Technical BULLETIN

SAFETY RECALL

2006 ~ 2010 YZF-R6 MODELS FACTORY MODIFICATION CAMPAIGN – Front Side Reflectors

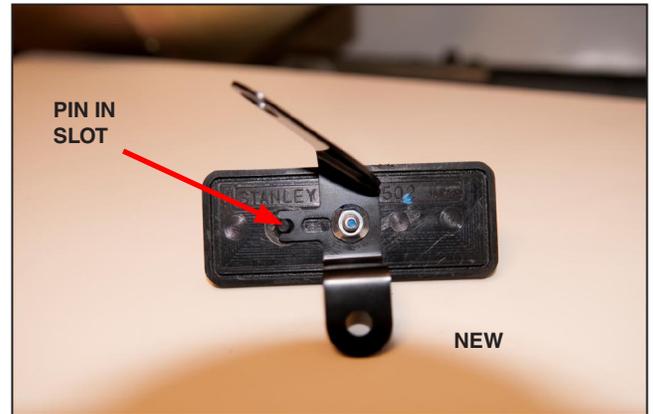
Yamaha Motor Corporation, U.S.A. has decided that a defect which relates to motor vehicle safety exists in 2006~2010 YZF-R6 model motorcycles. In affected motorcycles, the front side reflector height does not meet Federal Motor Vehicle Safety Standard §571.108 (Standard No. 108; Lamps, reflective devices, and associated equipment). This standard specifies that the center point of front side reflectors on a vehicle must be located between 381mm and 1524mm from the ground. The reflector center point on 2006~2010 YZF-R6 models is 358mm.

To correct this defect, Yamaha is initiating a Factory Modification Campaign. Affected units must have both right and left side front reflector brackets replaced with new type brackets that raise the reflector's center point to a position within the range specified by the regulation.

1. Remove the original front reflectors and brackets (RH & LH) by removing the 6mm Allen bolt and nut.

2. Remove the reflectors from the original brackets and install them on the new brackets, aligning the pin on the reflector with the corresponding slot in the new bracket.

3. Remove the upper brake caliper mounting bolts.

4. Install the new reflector brackets (RH & LH side) with the reflector installed, using the original mounting point and the new upper brake caliper mounting point. Torque the mounting bolts to specification
